SERVICE FLASH

## RF0803

### Garage Kit for Top Mounts

**BRAND** Frigidaire

Heater Kit

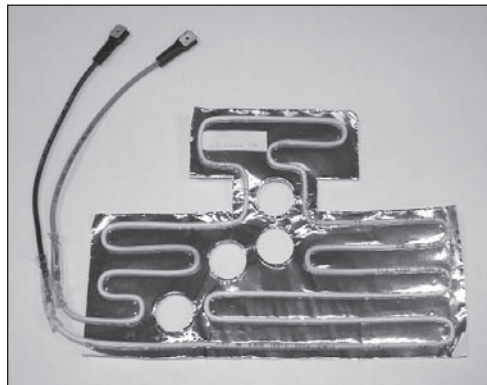
**PROBLEM** Top mount refrigerator installed in a garage and the food in the freezer is defrosting when the temperature in the garage goes below 55 degrees fahrenheit.

**CAUSE** On top mount refrigerators you cycle the compressor and fan/fans from the food compartment temperature. When the room temperature gets colder than 55 F, you have long off times waiting for the food compartment to warm enough to trip the cold control. This long off time is allowing the freezer temperature to get high enough that food can start to defrost.

**SOLUTION** There is a kit for refrigerators installed in applications where the temperature can go as low as 34 F and still maintain good freezer temperatures. The kit part number is 5303918301 and it contains a heater that mounts in the control box and an instruction sheet advising how to install the heater.

Kit 5303918301 contains:  
Part # 5303950194 Instruction sheet  
Part # 241532101 Heater
